### **AMENDMENTS TO THE DRAWINGS**

### REMARKS

Figure - 1

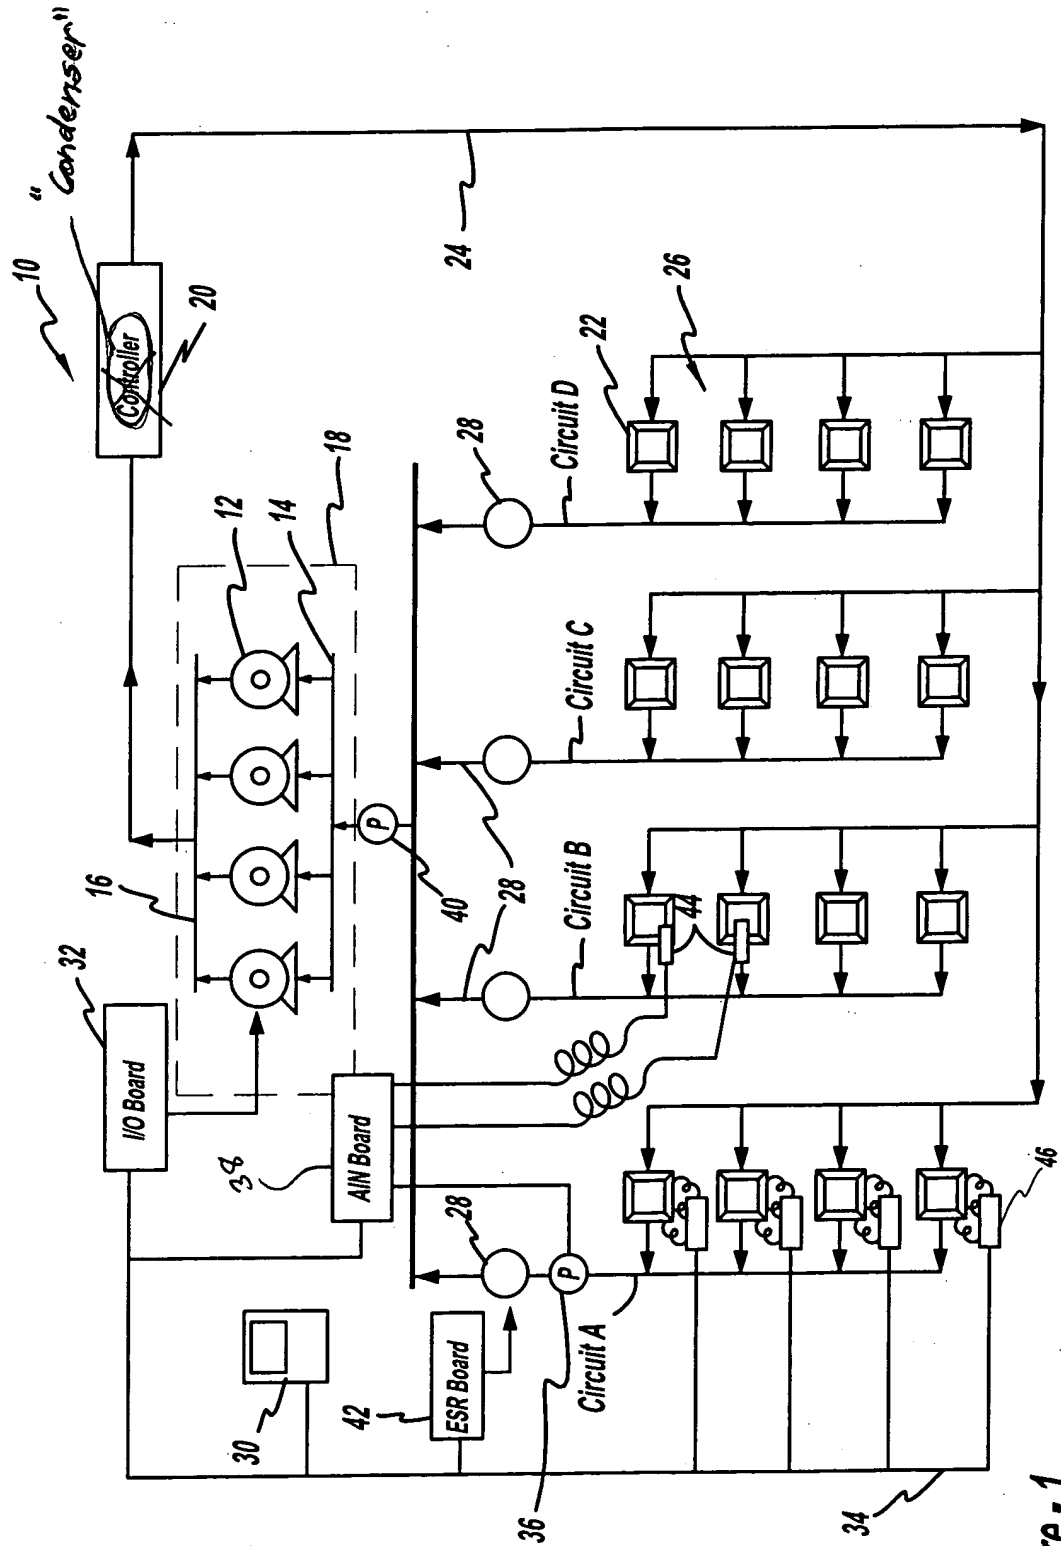
Applicants have attached revised drawings for the Examiner's approval. Applicants have amended FIGS. 1 and 3 to correct typographical errors. Specifically, Element 20 of FIG. 1 is now properly designated as a "condenser" rather than a "controller" and the control logic of FIG. 3 is now properly designated by reference numeral "60" rather than reference numeral "50." Favorable consideration of the revised drawings is respectfully requested.
